ADDENDUM No. Two (2)

IFB No. 2019-183

CONSTRUCTION, REROOF COLLIN COUNTY 920 E. PARK BLVD., PLANO

ADDENDUM NUMBER 1

Sheet No. R1.0
of 2 Sheets

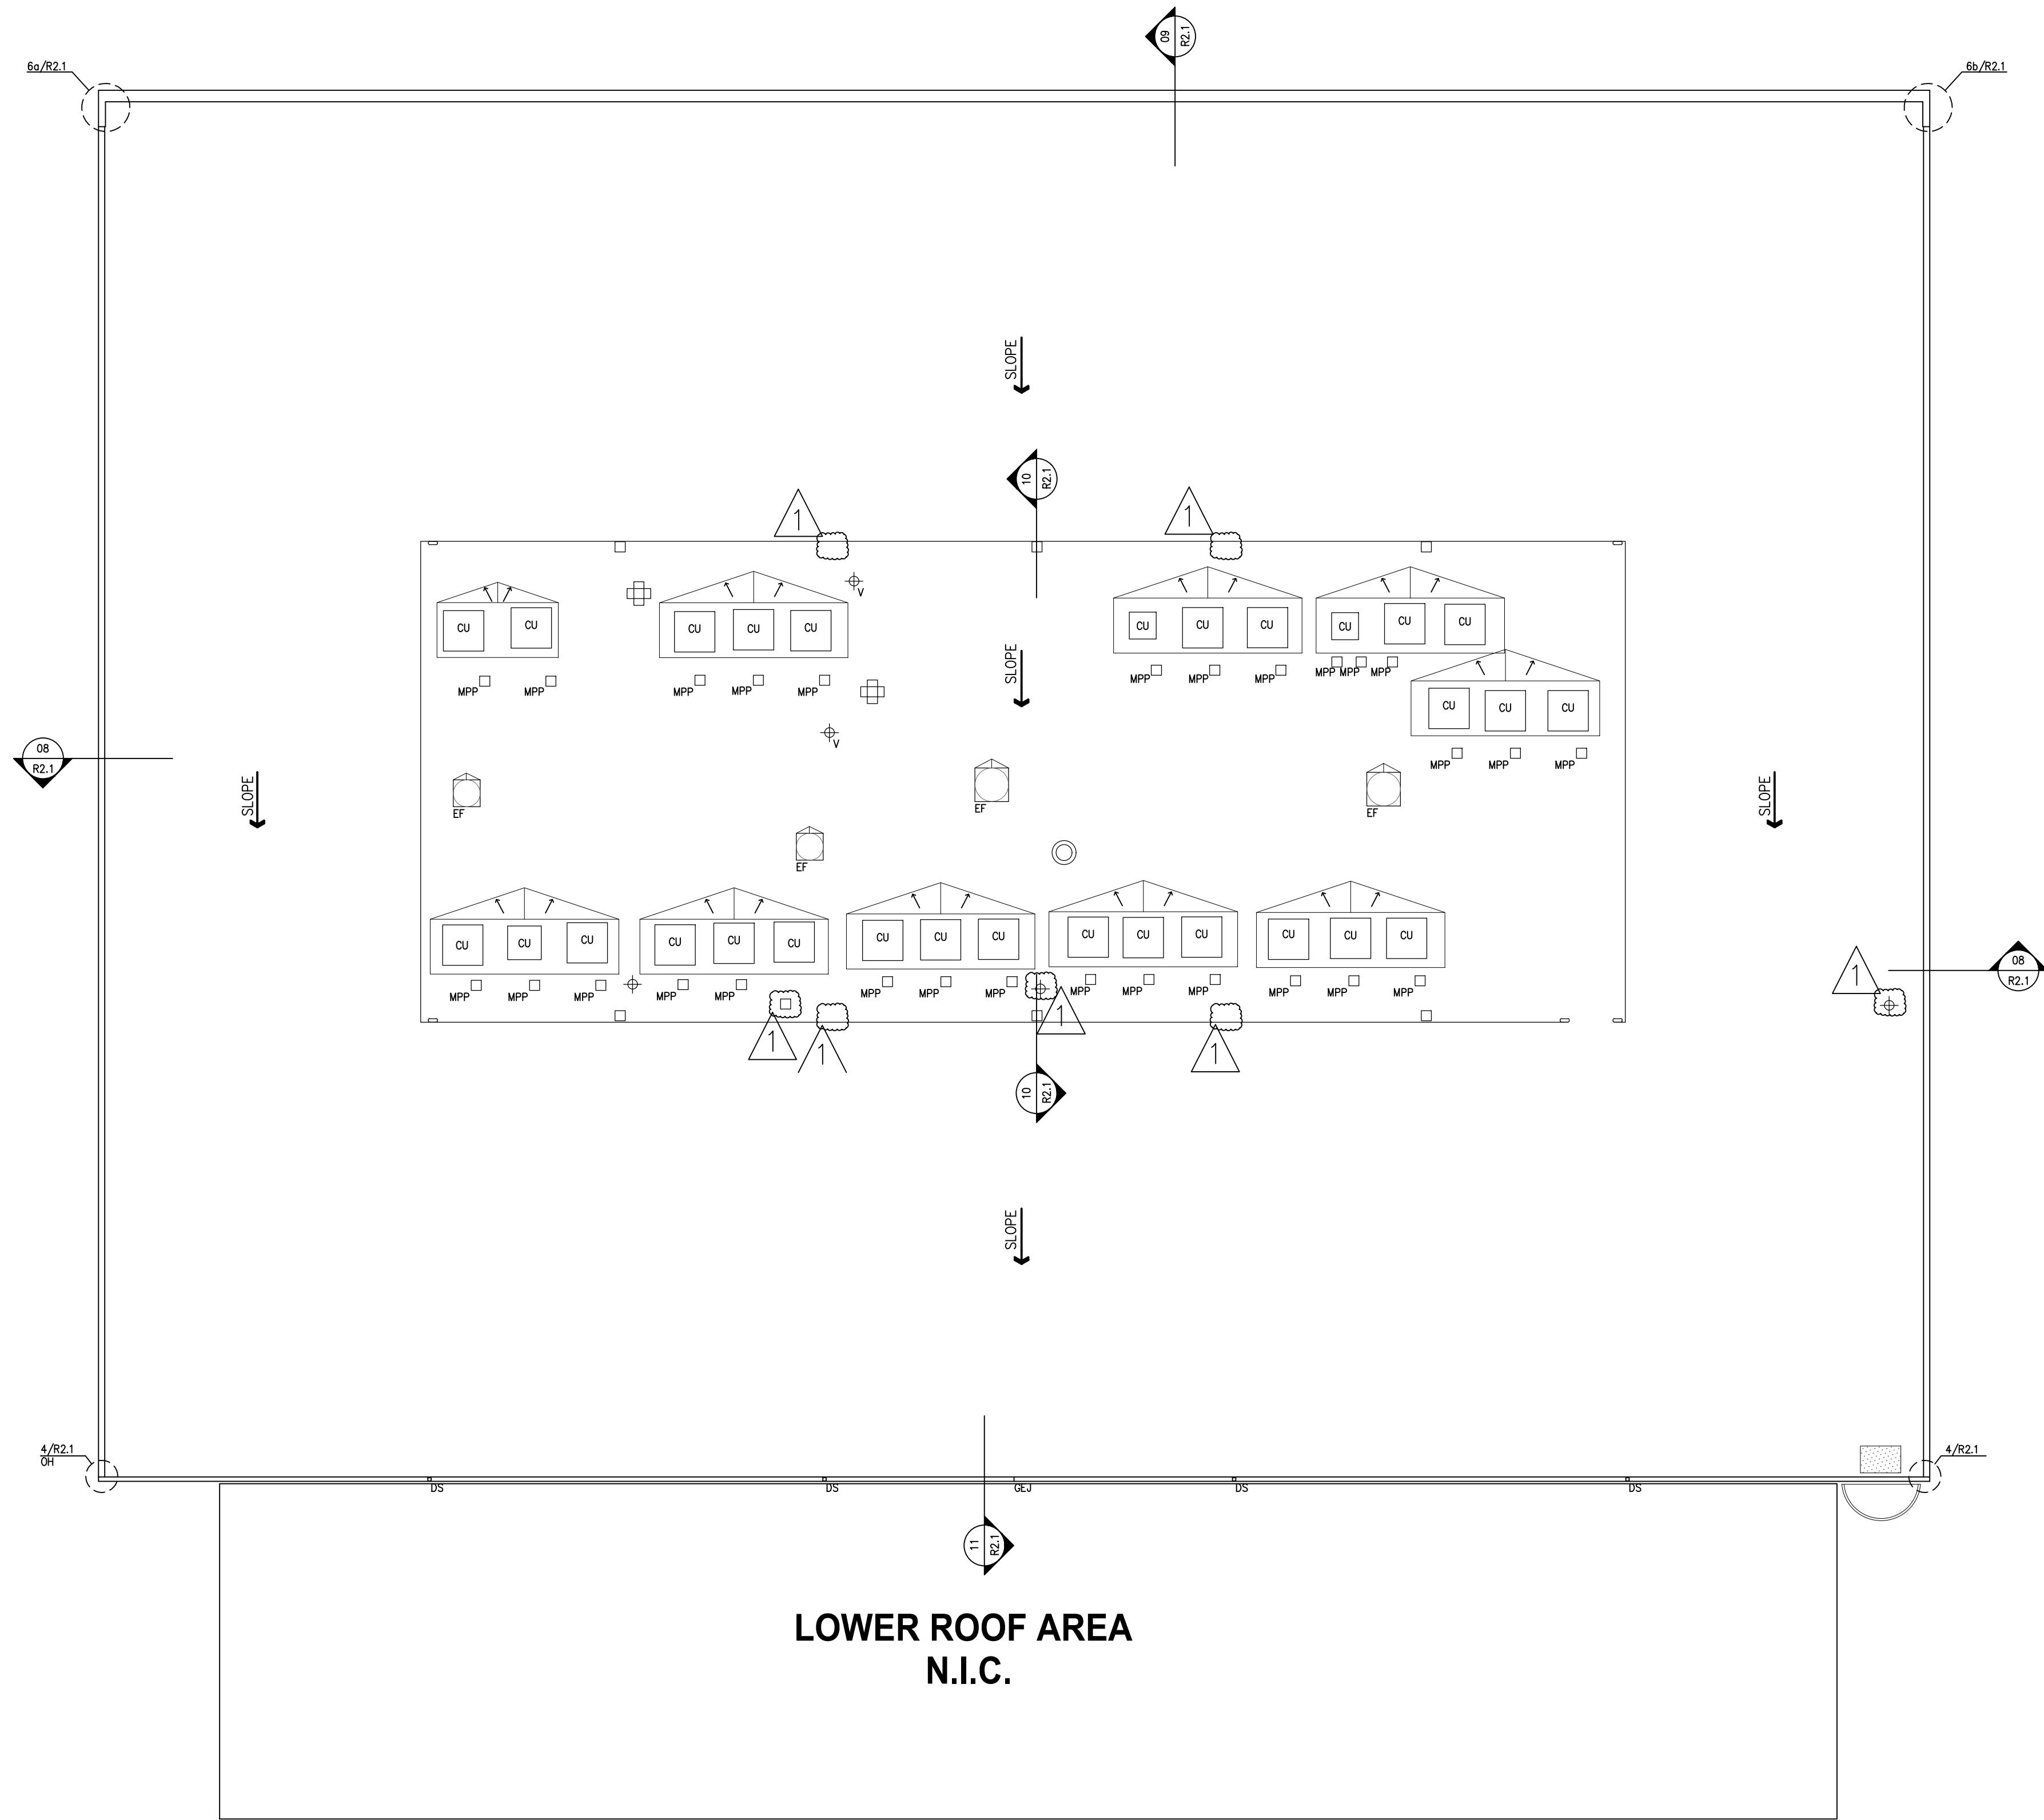
1. The attached revised Sheets R1.0, R1.1 and R2.1 replace the original Sheets R1.0, R1.1 and R2.1 with the changes associated with the Addendum being noted and clouded.
2. The attached Sheet R2.2 is added to the Contract Documents and includes information related to where a dumpster can be positioned, where roofing materials can be staged and where the sky track can be parked.
